MEMORANDUM

TO: District of Columbia Board of Zoning Adjustment
FROM: Maxine Brown-Roberts, Project Manager
 Joel Lawson, Associate Director, Development Review
DATE: December 31, 2012
SUBJECT: BZA 18477 – 1400-1404 14th Street, NW

BOARD OF ZONING ADJUSTMENT
 District of Columbia
CASE NO. 18477
EXHIBIT NO. 27

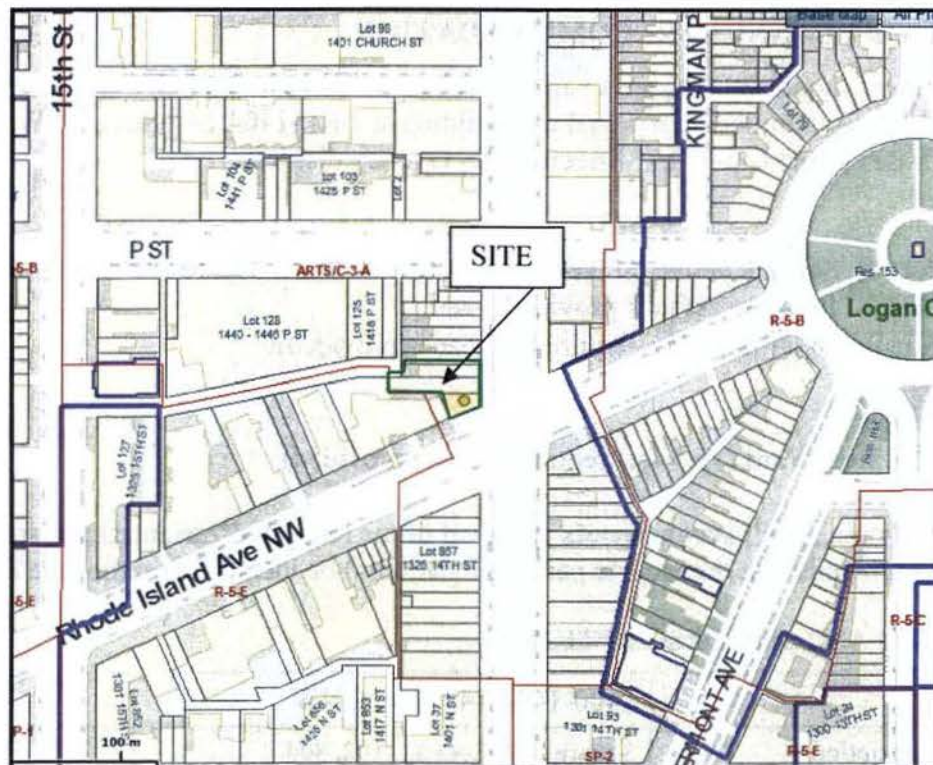
The Office of Planning (OP) **recommends** approval of the requested variances and special exception and further recommends that the bicycle parking location(s) be identified on the Site Plan

² The applicant proposes to provide 12 bicycle spaces to help mitigate the reduction in parking spaces. However, the location of the bicycle parking spaces is not shown on the plans.
